Service Letter: No. 326

Subject: Inspection of 412AC-5040-3 Accumulator, when installed with Aeronautical Accessories Hoist Kit (P/N 412-150-400).

Applicability: Bell Helicopter Model 412

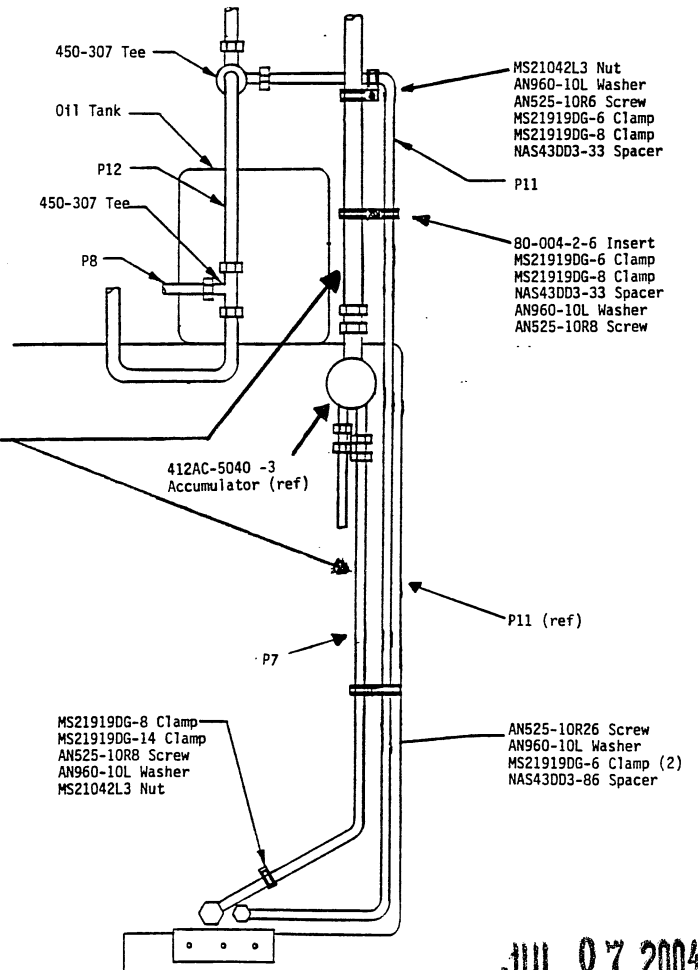
If repositioning of lines becomes necessary, make adjustments in the areas indicated.

Making adjustments to close to the fittings may cause leaks.

4. If no damage is found reapply insulation to the accumulator body.
5. Reposition lines so that no contact or interference occurs between the aircraft structures and the accumulator assy.
 - a. note: that the air conditioner plumbing lines are made of very soft aluminum, and therefore can be reshaped very easily.
